## 5 HILLWAY, NEDLANDS – AMENDMENT TO DEVELOPMENT APPROVAL (REDUCTION IN NUMBER OF DWELLINGS)

### Form 2 – Responsible Authority Report (Regulation 17)

<b>DAP Name:</b>	Metro Inner-North JDAP	
<b>Local Government Area:</b>	City of Nedlands	
<b>Proposed Amendments:</b>	Modification to approved plans to reduce the number of dwellings from 10 as approved to 9.	
<b>Applicant:</b>	Element Advisory Pty Ltd	
<b>Owner:</b>	Hillway 20 Pty Ltd and Hillway 80 Pty Ltd	
<b>Value of Amendment:</b>	N/A	
<b>Responsible Authority:</b>	City of Nedlands	
<b>Authorising Officer:</b>	Peter Mickleson, Director Planning and Development	
<b>LG Reference:</b>	DA20/55430	
<b>DAP File No:</b>	DAP/20/01741	
<b>Date of Original DAP decision:</b>	29 September 2020	
<b>Application Received Date:</b>	13 October 2020	
<b>Application Statutory Process Timeframe:</b>	60 Days	
<b>Attachment(s):</b>	<ol style="list-style-type: none"> <li>1. Amended Plans date stamped 28 October 2020</li> <li>2. Applicant Letter and overview dated 9 October 2020</li> <li>3. Previous Determination Notice and approved plans.</li> <li>4. Letter from Lavan Legal dated 8 October 2020</li> </ol>

**SILVER LEVEL CRITERIA**  
Applicable to Apartments 101 & 501

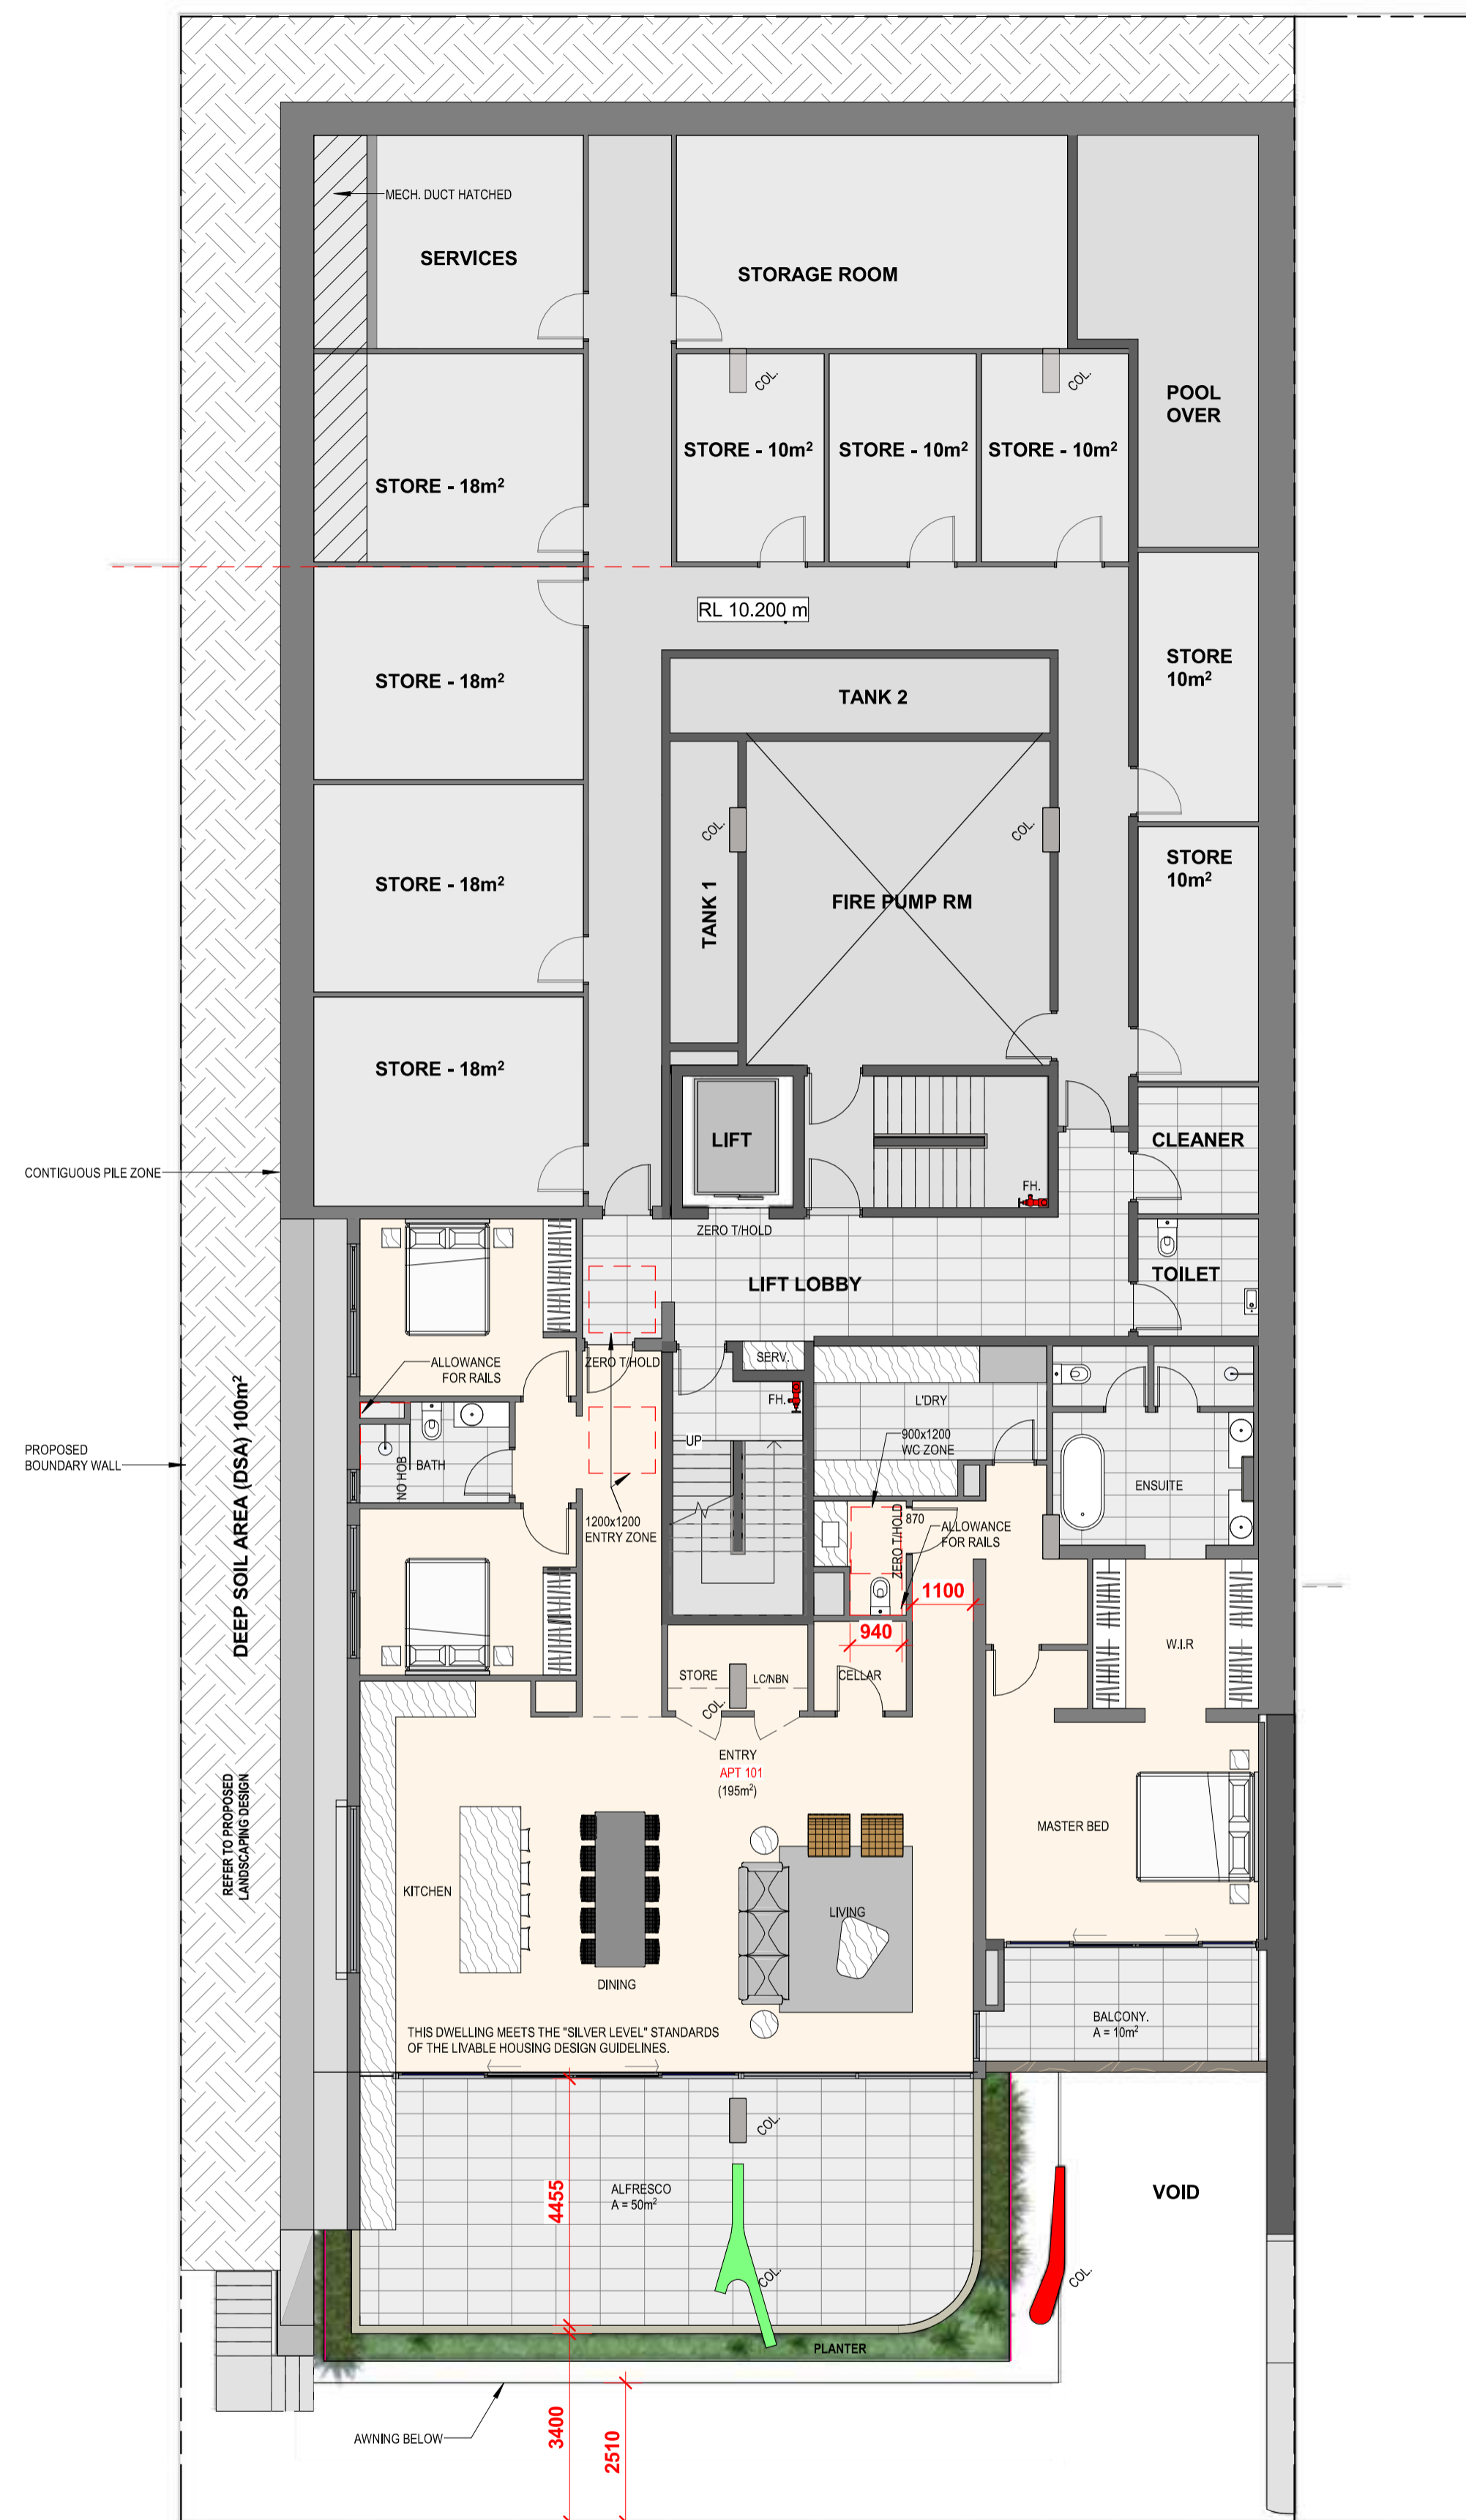
The deletion of Apartment 303 has required a change to the nominated Silver Level accessible dwellings. The approved plan indicated Apartments 101 and 303 would be constructed to Silver Level as defined by the *Liveable Housing Design Guidelines*. The provision of two dwellings (20% of total) met Acceptable Outcome A4.9.1(a) of the Residential Design Codes Volume 2. The revised plans now indicate that Apartments 101 and 501 will be constructed to Silver Level requirements.

The approved plans indicated Apartments 101 and 303 would be constructed to the Silver Level as defined by the *Liveable Housing Design Guidelines*. As Apartment 303 has been removed, it is now proposed that Apartments 101 and 501 are constructed

2. Amend Condition 25 to read as follows:

*Two (2) multiple dwellings (Units 101 and 501) on the hereby approved plans shall meet 'Silver Level' universal access requirements as defined by the Liveable Housing Design Guidelines.*
